Re: **Report Transmittal**
Monitoring Well Destruction and Replacement Addendum Report
76 Service Station #5760
376 Lewelling Boulevard
San Lorenzo, California

**RE: Monitoring Well Destruction and Replacement
Addendum Report
76 Service Station No. 5760
376 Lewelling Boulevard
San Lorenzo, California**

Subject: Fuel Leak Case No. RO0000344 and Geotracker Global ID T0600101469, UNOCAL #5760, 376 Lewelling Boulevard, San Lorenzo, CA 94580

Well Construction Detail

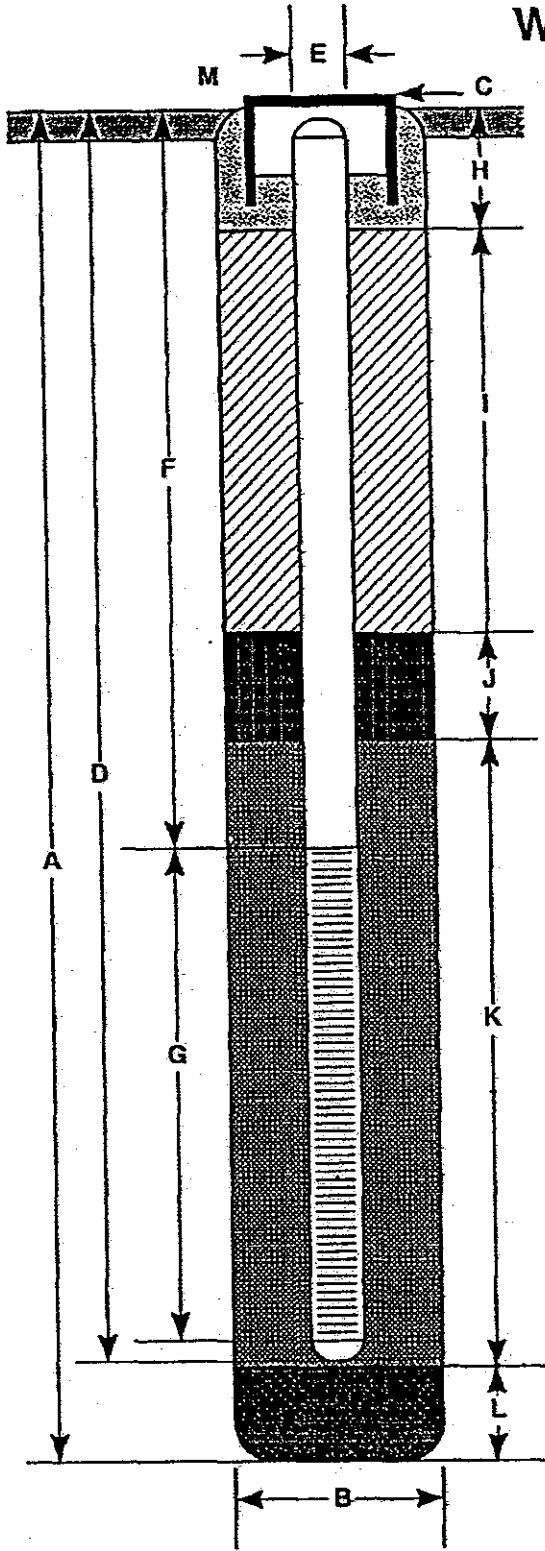
- The original well construction details for U-1 and U-3 were not provided in either the work plan or the report. Information on the auger size used for the original wells is needed to ensure that the wells have been properly destroyed. Please provide the original well construction details for U-1 and U-3 in the addendum requested below.
